**SN J1981B-01**

**S E R V I C E N O T E**

J1981B VQT

**Updated replacement of analog card for improved PESQ scores**

Move metal tab to  
new assembly

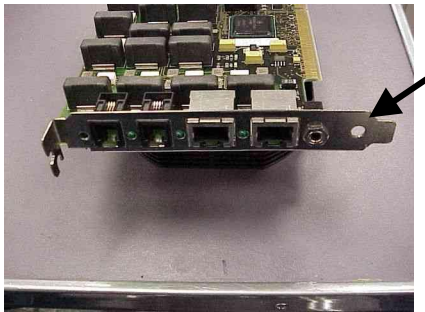
Replace the analog FXO E&M card with the latest version. This, along with downloading the VQT application Software Version 4.1.1 or later. When the “defective” analog card is removed the metal grounding tab MUST be swapped to the new assembly.
